# **ADDENDUM NO. 2**

**SPIETH HALL ROOF REPLACEMENT AND  
MECHANICAL UPGRADE**

**PROJECT NO. 950599**

### Addendum #1 Work Sequence Narrative

Drawing Name  
**BASEMENT POWER**  
**RECONSTRUCTION PLAN**  
 Sheet No.  
**E2.1**  
 OF

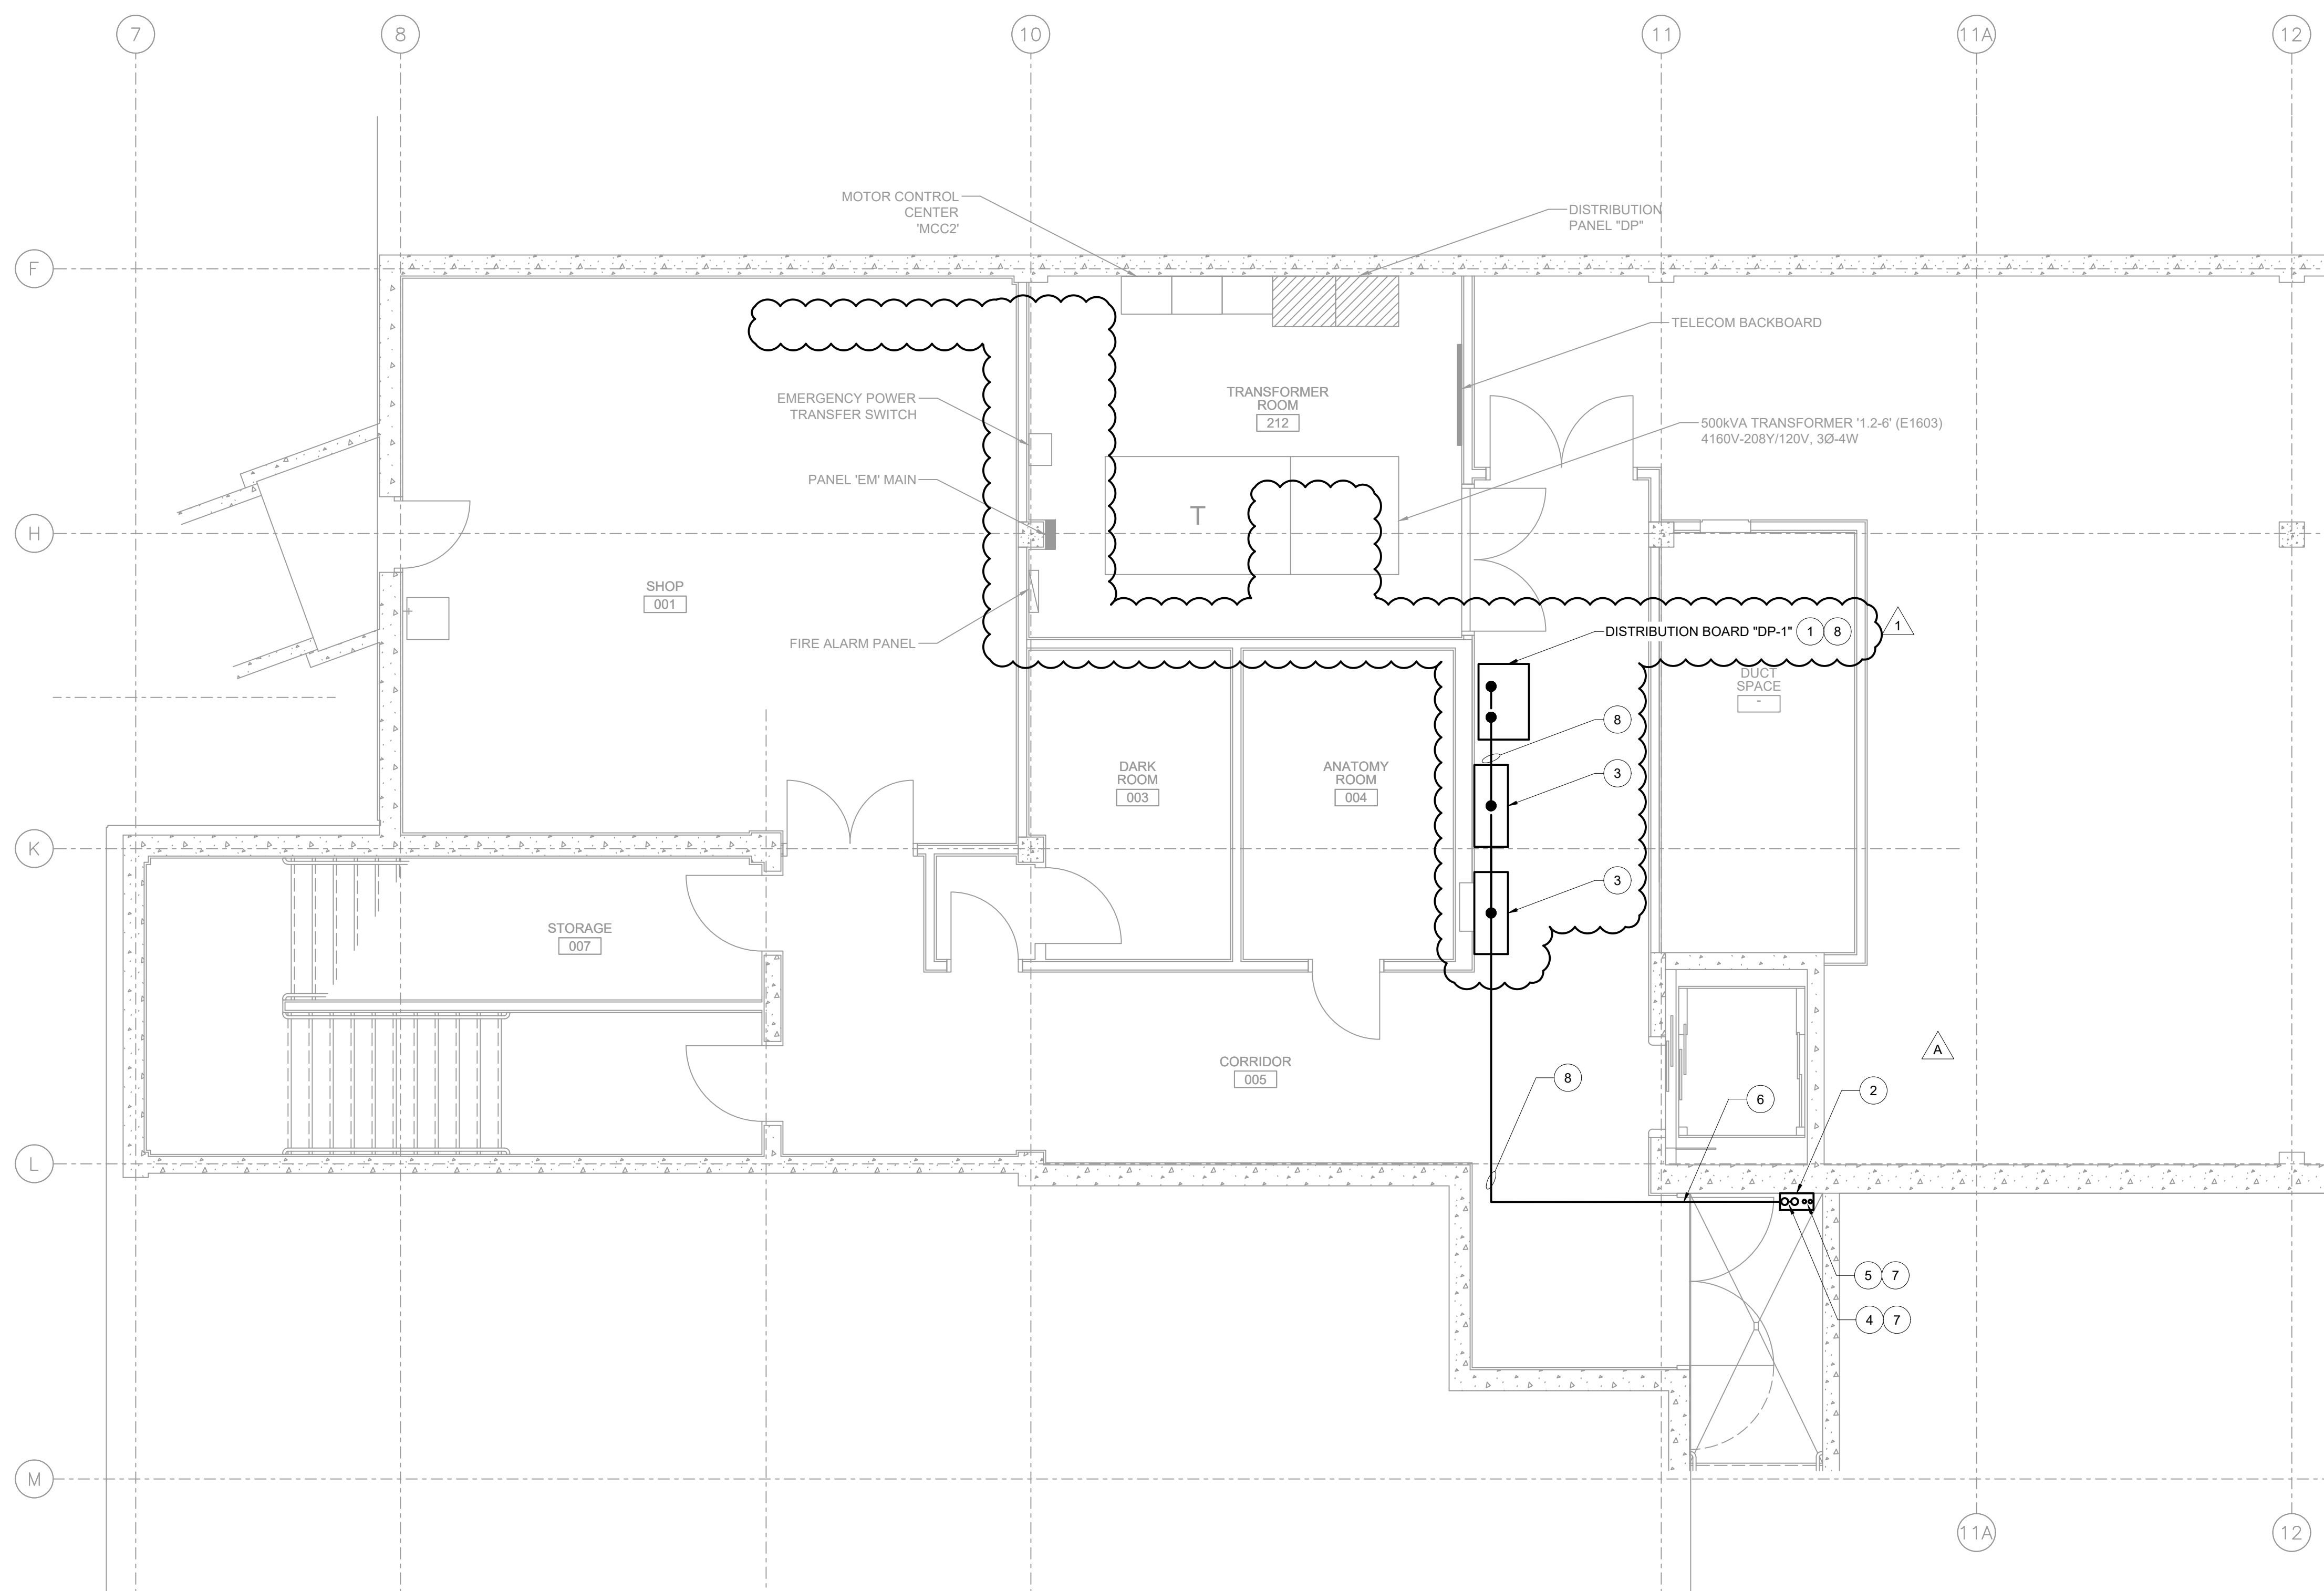
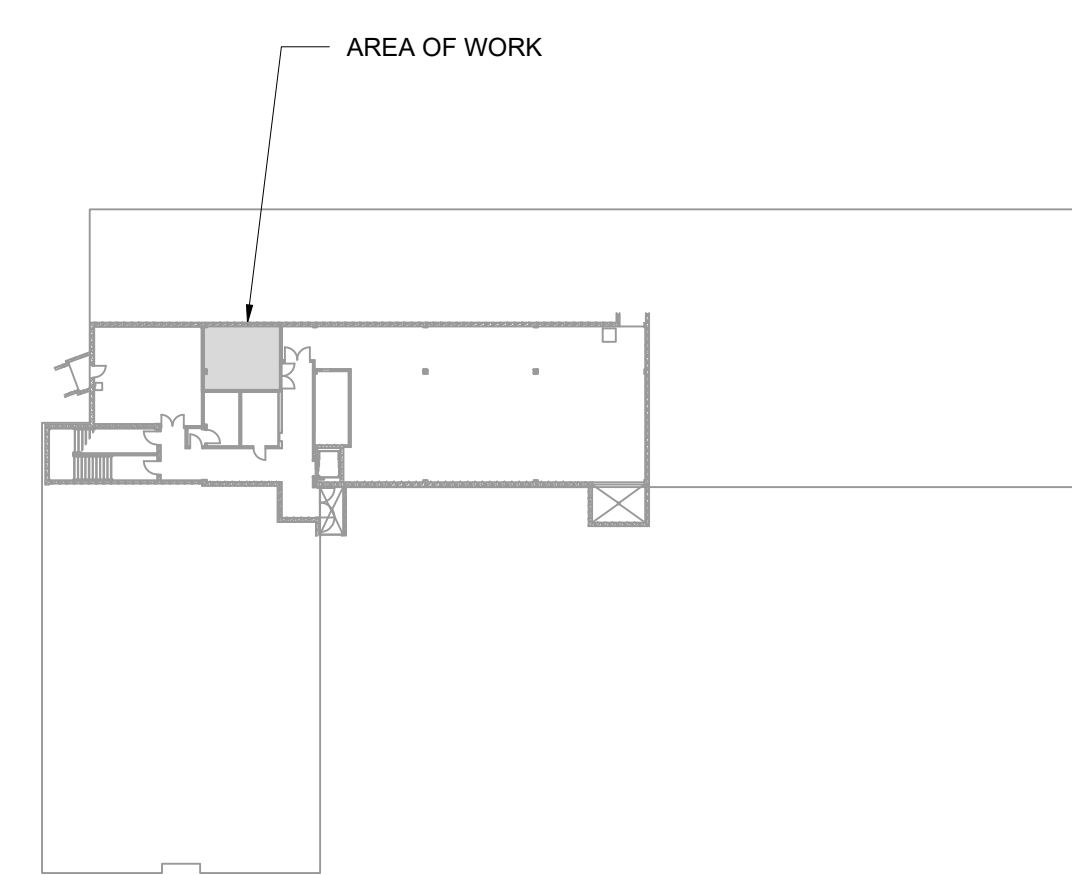
##### Sheet E2.1:

1. Updated the location of new Distribution Board 'DP-1'.
2. Updated the location of new VFD's.

- 1 NEW DISTRIBUTION BOARD "DP-1".
- 2 PROVIDE A 16" x 16" x 6" PULLBOX. SEE SPECIFICATIONS FOR ENCLOSURE TYPE.
- 3 NEW VFD, INSTALLED AND/OR MOUNTED BY MECHANICAL. WIRING TERMINATION BY ELECTRICAL. SEE SINGLE LINE DIAGRAM ON SHEET E6.2 FOR MORE INFORMATION. COORDINATE WORKS WITH MECHANICAL DRAWINGS.
- 4 (2) 2" C TO RISE UP TO ROOF LEVEL FOR EXHAUST FAN'S POWER CONDUCTORS. SEE SINGLE LINE DIAGRAM ON SHEET E6.2 FOR MORE INFORMATION.
- 5 (2) 3/4" C TO RISE UP TO ROOF LEVEL FOR EXHAUST FAN'S DISCONNECT SWITCH CONDUCTORS BACK TO THE NEW VFD'S.
- 6 SEE DETAIL 3 ON SHEET E5.1. EXTERIOR CONDUIT/S SHALL BE PAINTED TO MATCH EXISTING EXTERIOR WALL FINISH.
- 7 SEE DETAIL 1 ON SHEET E5.1. EXTERIOR CONDUIT/S SHALL BE PAINTED TO MATCH EXISTING EXTERIOR WALL FINISH. SEE SHEET E2.4 FOR CONTINUATION.
- 8 SEE SINGLE LINE DIAGRAM ON SHEET E6.2 FOR MORE INFORMATION.

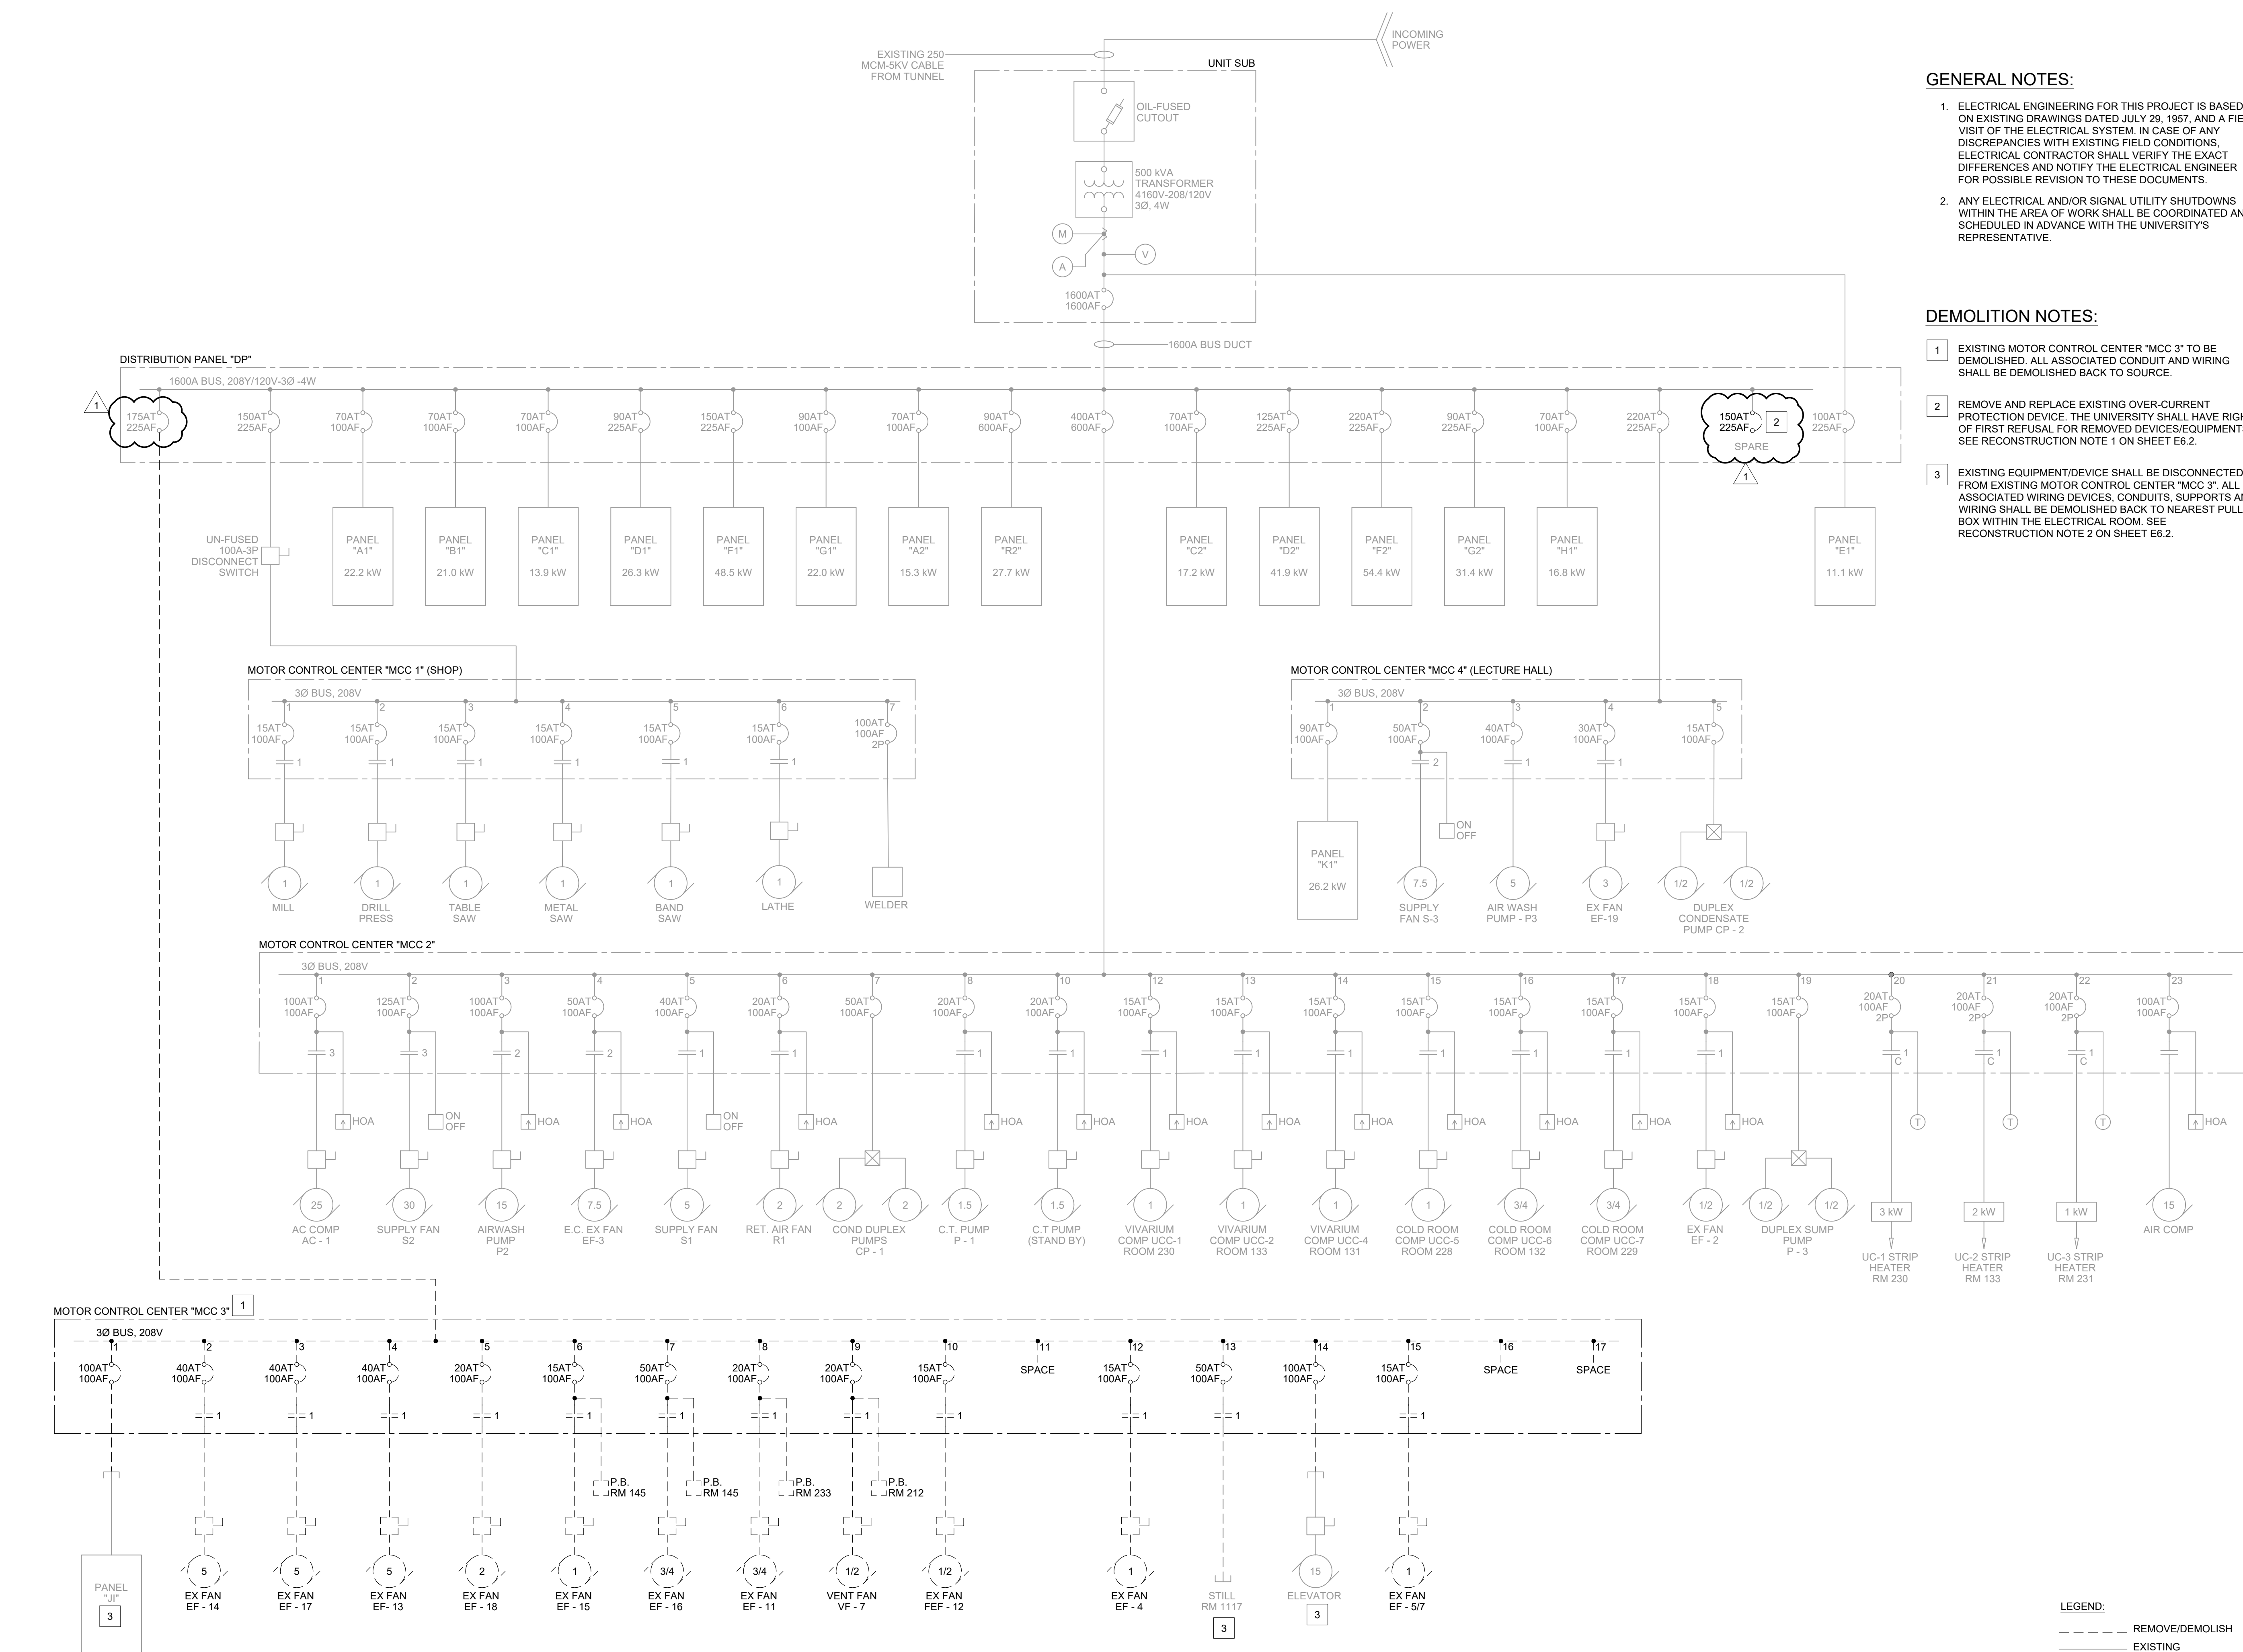
##### Sheet E6.1:

1. In existing Distribution Panel 'DP', the existing 175AT/225AF circuit breaker serving existing motor control center 'MCC3', is to remain and be protected in-place.
2. In existing Distribution Panel 'DP', the existing spare 150AT/225AF circuit breaker shall be removed and replaced.

1. EXISTING MOTOR CONTROL CENTER "MCC 3" TO BE DEMOLISHED. ALL ASSOCIATED CONDUIT AND WIRING SHALL BE DEMOLISHED BACK TO SOURCE.
2. REMOVE AND REPLACE EXISTING OVER-CURRENT PROTECTION DEVICE. THE UNIVERSITY SHALL HAVE RIGHT OF FIRST REFUSAL FOR REMOVED DEVICES/EQUIPMENTS. SEE RECONSTRUCTION NOTE 1 ON SHEET E6.2.
3. EXISTING EQUIPMENT/DEVICE SHALL BE DISCONNECTED FROM EXISTING MOTOR CONTROL CENTER "MCC 3". ALL ASSOCIATED WIRING DEVICES, CONDUITS, SUPPORTS AND WIRING SHALL BE DEMOLISHED BACK TO NEAREST PULL BOX WITHIN THE ELECTRICAL ROOM. SEE RECONSTRUCTION NOTE 2 ON SHEET E6.2.
